Preliminary Plan 120170180, Hayes (Formerly 4100 Jones Bridge Road)

Staff Report Date: 10/19/2017

Description

Figure 1 – Preliminary Plan

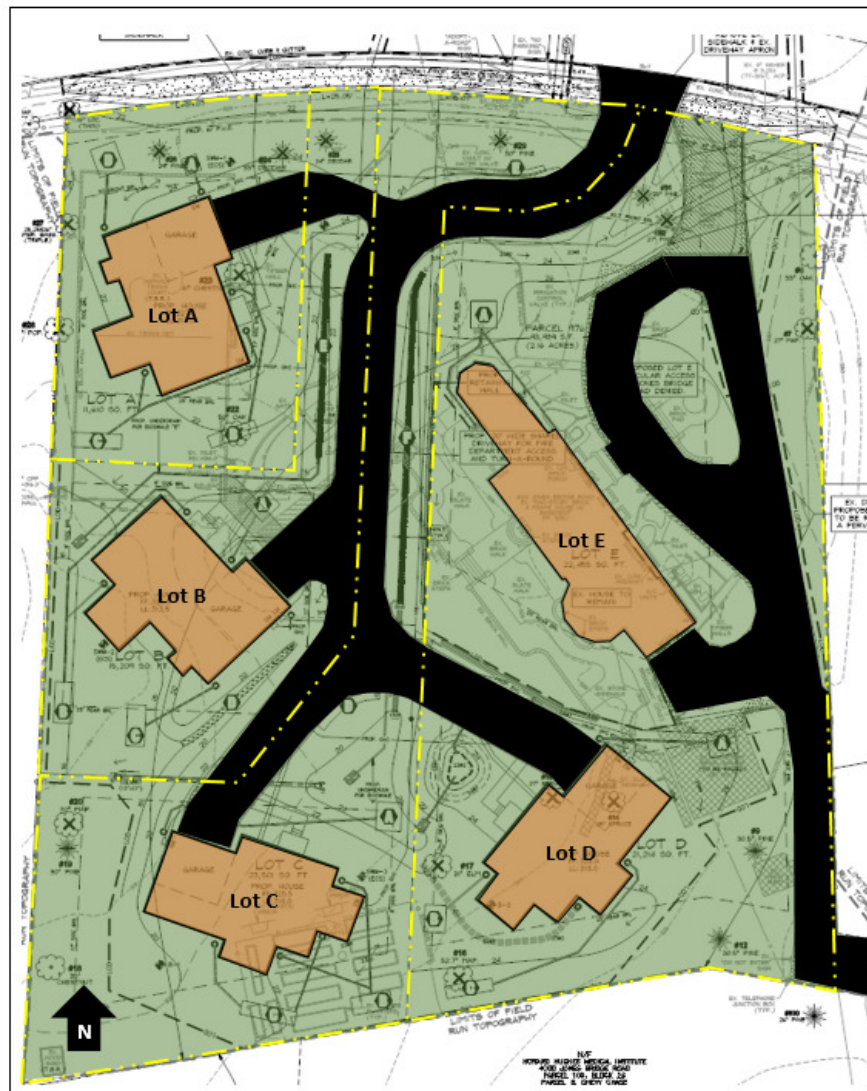
The Applicant proposes to subdivide the Subject Property (Parcel 976; I. 16423 / F. 658) into five lots for five one-family detached dwellings, four of which will be new dwellings (Figure 1). The existing dwelling on the Property will be retained on proposed Lot E and all accessory structures, the existing pool, and the existing tennis court will be removed. The lots will range in size from 11,610 square feet (proposed Lot A) to 23,501 square feet (proposed Lot C). Access to proposed Lots A, B, C, and D will be via a shared driveway off Jones Bridge Road, and access to proposed Lot E (the existing dwelling unit) will be via an individual driveway, over Lot D, from Platt Ridge Drive. Pedestrian access will be provided by a proposed reconstruction of the sidewalk along the Jones Bridge Road frontage.

- a. The right-of-way centerline for Jones Bridge Road with a dimension of at least 40-feet between the right-of-way centerline and proposed property line.

Figure 2 – Pervious Pavement

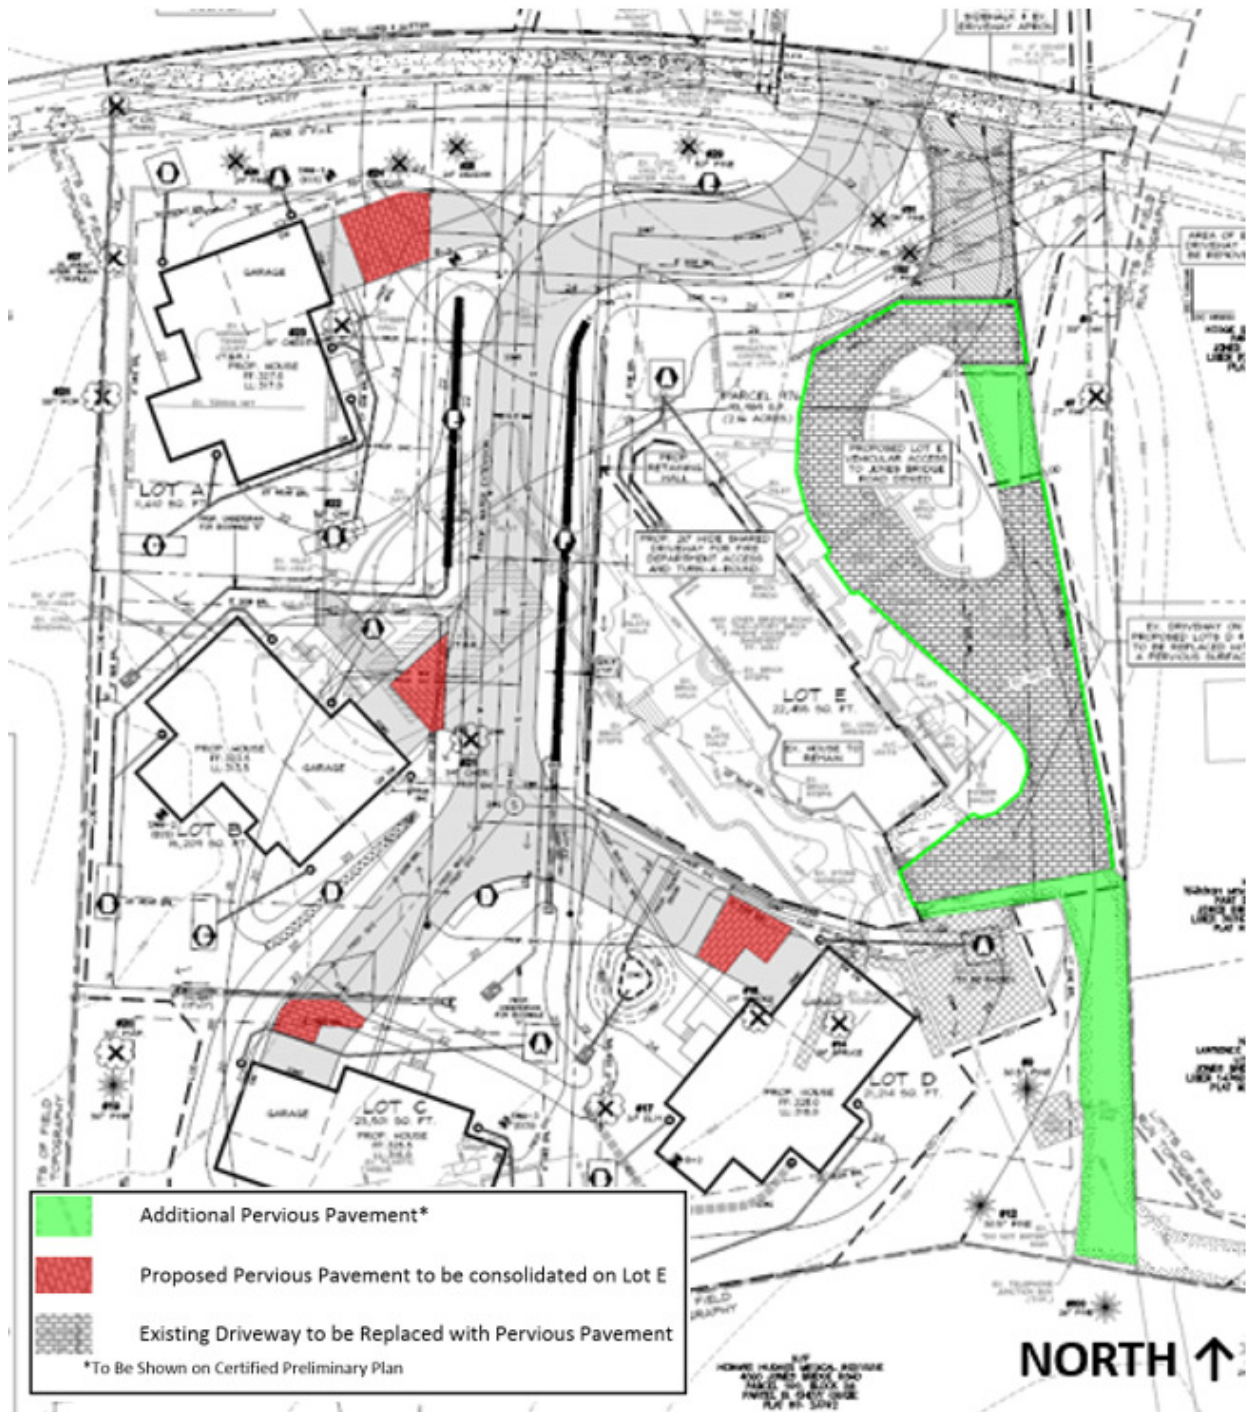
The Sector Plan recommends sustainable site and building design to mitigate negative environmental impacts. In response to this recommendation, the Applicant proposed specific areas of the driveways and sidewalk as pervious pavement. As currently proposed, each of the five proposed lots has a small amount of pervious pavement, however, the pervious areas are small and disconnected due to constraints imposed by the proposed building footprints and the common driveway fire access lane. Staff suggested that these small disconnected pervious areas be eliminated from Lots A – D and consolidated on Lot E to maximize the effectiveness and practicality of the pervious area. The consolidation of proposed pervious pavement is shown in Figure 2, below. As conditioned, the pervious pavement provided within the Lot E driveway and on-site stormwater management will support the Sector Plan recommendations.

- b. Consolidation of the common driveway pervious pavement material, shown on the Preliminary Plan dated August 29, 2017, onto the Lot E driveway. As a result, all pervious pavement will be located within the Lot E driveway.

Figure 3 – Jones Bridge Road 2040 Traffic Noise Exposures (Preliminarily estimated day-night average sound levels)

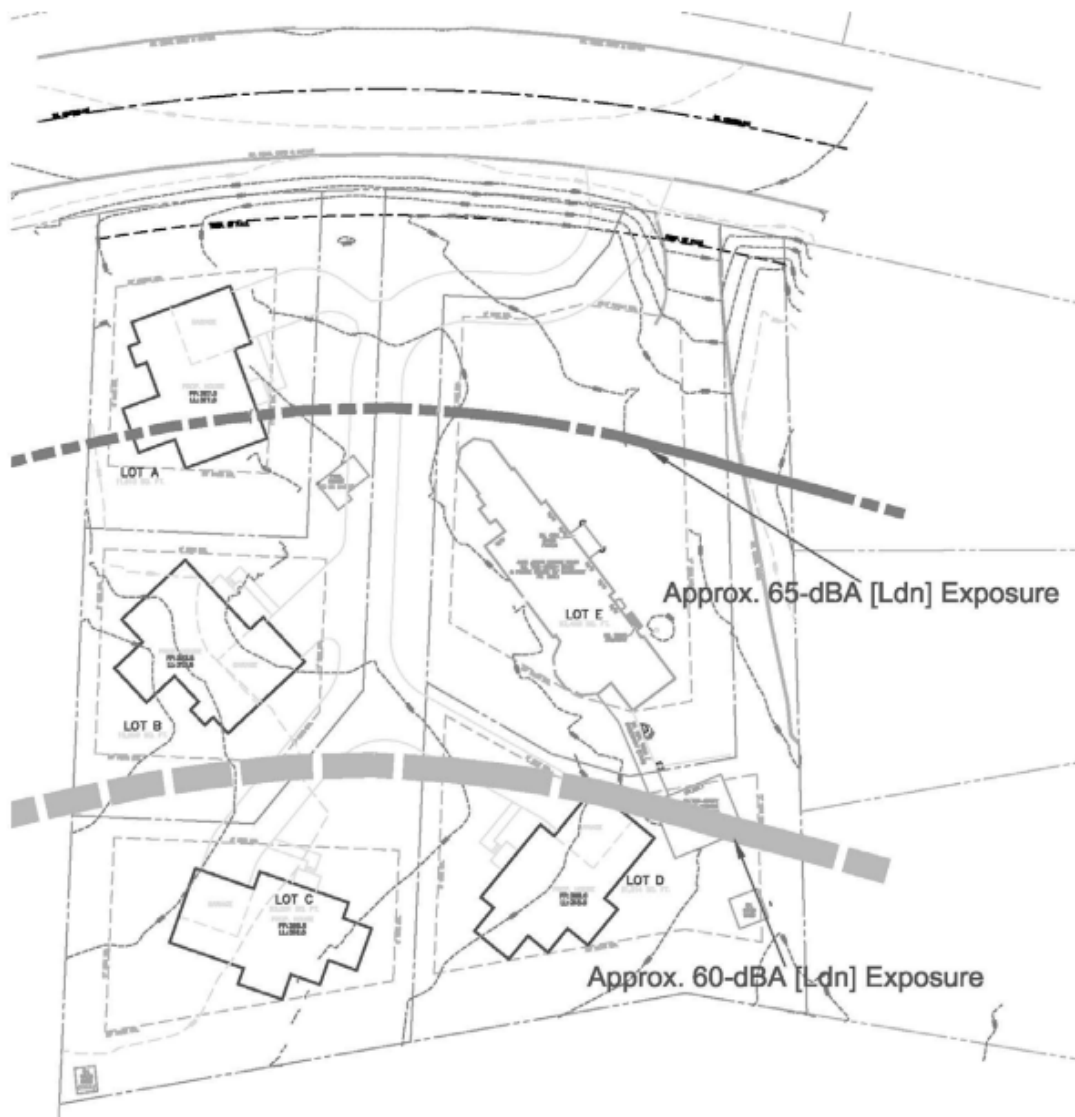
The preliminary noise study shows that proposed Lot “A” (adjacent to Jones Bridge Road) would experience excessive levels of noise impacts (more than the levels allowed in noise guidelines- 65 dBA Ldn). The analysis also states that the interior noise levels of the affected home can be mitigated to the required levels (below 45 dBA Ldn) by appropriate building shell construction. Staff notes that as depicted, the rear yard of Lot “A” is shown beyond the mapping of excessive noise, and would therefore not require any noise mitigation measures (the structure itself would also be expected to provide additional shielding to further decrease noise levels in the backyard). However, Staff has remaining concerns the analysis is based entirely on computer modeling and is not calibrated with actual field measurements as traditionally performed on other development projects. Staff recommends a condition of approval for the onsite measurements to be performed and the analysis (and plans as applicable) be revised prior to certification of the Preliminary Plans and FFCP. Standard conditions of approval relative to noise are also recommended.

- 4) Noise Attenuation:
 - a. Prior to the certification of the Preliminary Plan and FFCP, the Applicant must provide a revised noise analysis which is based on field measurements of the existing noise levels occurring on the subject property. The analysis must also show the existing and 20-year projected noise contours.

- b. Prior to issuance of a building permit for any residential dwelling unit(s) to be constructed within the projected 65 dBA Ldn noise contour, the Applicant must provide Staff with certification from an engineer specializing in acoustics that the building shell has been designed to attenuate projected exterior noise levels to an interior level not to exceed 45 dBA Ldn.
